# Evaluation of Physical Barriers- Moreno Valley / March Field Station

Address: 14160 Meridian Pkwy, Riverside, CA 92518

Evaluation Date: 08-05-2021

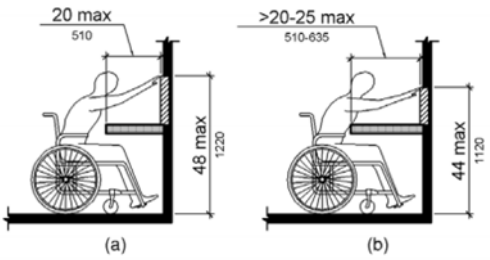
a) Pedestrian Push Button- Not Applicable	No action by RCTC	
<b>3. Accessible Routes</b>		
a) Walking surface		
<p>Aisles at the ADA parking spots have level changes where asphalt is higher than the concrete</p> 	<p>Examine all parking aisles, accessible routes, and curb ramps.</p> <p>Every joint deeper than <math>\frac{1}{4}</math>" and wider than <math>\frac{1}{2}</math>" shall be filled.</p> <p>Every level change along the accessible route greater than <math>\frac{1}{4}</math>" and less than <math>\frac{1}{2}</math>" height needs to be beveled (1:2) slope or repaired.</p> <p>Every level change greater than <math>\frac{1}{2}</math>" needs to have a ramped surface (1:12) slope.</p>	 <p><b>Figure 302.3</b> Elongated Openings in Floor or Ground Surfaces</p>  <p><b>Figure 303.3</b> Beveled Change in Level</p>  <p><b>Figure 303.2</b> Vertical Change in Level</p>

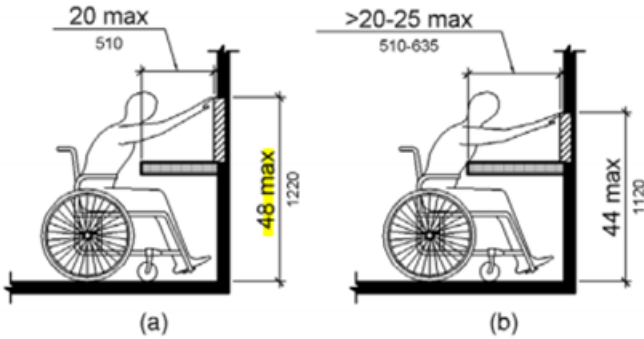
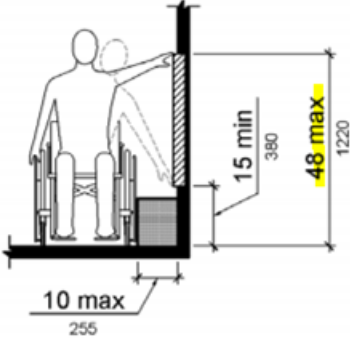
b) Drinking Fountains		
Drinking Fountain is not provided at this station.	No action by RCTC	
c) Telephones/ Communication Systems	See Attachment 9, Action Plan for recommendations	Clear space and reach ranges are found to be compliant. All instruments are to be tested regularly for compliance by the responsible authorities.
<p>i. Passenger Information Phone: OK</p> 	No action by RCTC	<p>704.2.1 Clear Floor or Ground Space. A clear floor or ground space complying with 305 shall be provided. The clear floor or ground space shall not be obstructed by bases, enclosures, or seats.</p> <p>704.2.2 Operable Parts. Operable parts shall comply with 309. Telephones shall have push-button controls where such service is available.</p> <div style="display: flex; justify-content: space-around; align-items: flex-end;"> <div style="text-align: center;">  <p><b>Figure 308.3.2</b> Obstructed High Side Reach</p> </div> <div style="text-align: center;">  <p><b>Figure 308.2.2</b> Obstructed High Forward Reach</p> </div> </div>
